Access Compliance Report

Public Rights-of-Way (Curb Ramps)

Intersection ID: 50585	Main Street: GRAND_FIR_RD	Cross Street: BENDING_BRANCH_RD	Location: SW
ADA ID: 8DB041E9F4BA	Ramp Type: Perp	Initial Pass/Fail: Fail	Overall Compliance: No
		Severity Score: 10

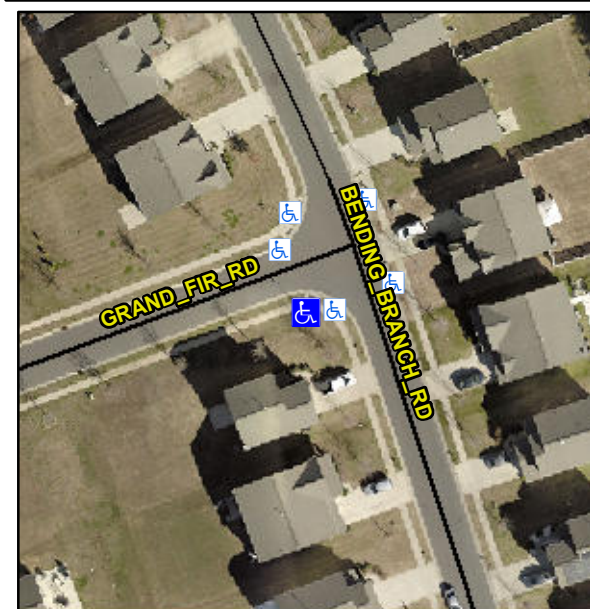
Not Found, R304.5.1, R304.5.3

Compliance	Description	Data	Compliance	Description	Data
N/A	Ramp Length (in)	47.0	Yes	Ramp Slope (%)	5.1
No	Ramp Width (in)	47.0	No	Ramp XSlope (%)	4.4
N/A	Flare Type LT	N/A	N/A	Flare Type RT	N/A
N/A	Flare Slope LT (%)	N/A	N/A	Flare Slope RT (%)	N/A
N/A	Flare Traversable LT?	N/A	N/A	Flare Traversable RT?	N/A
N/A	Landing Length (in)	N/A	N/A	DWS Provided?	N/A
N/A	Landing Width (in)	N/A	N/A	DWS Contrast?	N/A
N/A	Landing Slope (%)	N/A	N/A	DWS Length (in)	N/A
N/A	Landing X Slope (%)	N/A	N/A	DWS Full Width?	N/A
N/A	Landing Curb? (Y/N)	N/A	N/A	DWS Offset (in)	N/A
N/A	Shared Landing?	N/A			
N/A	Gutter Ponding?	N/A	N/A	Gutter Slope (%)	N/A
N/A	Gutter Lip Ht (in)	N/A	N/A	Gutter X Slope (%)	N/A
N/A	Painted X Walk1?	No	N/A	Painted X Walk2?	N/A
	X Walk 1 Direction	To N		X Walk 2 Direction	N/A
N/A	X Walk 1 Width (in)	N/A	N/A	X Walk 2 Width (in)	N/A
	X Walk 1 Slope (%)	0.0		X Walk 2 Slope (%)	N/A
	X Walk 1 X Slope (%)	5.4		X Walk 2 X Slope (%)	N/A

Remove & Replace Entire Ramp.
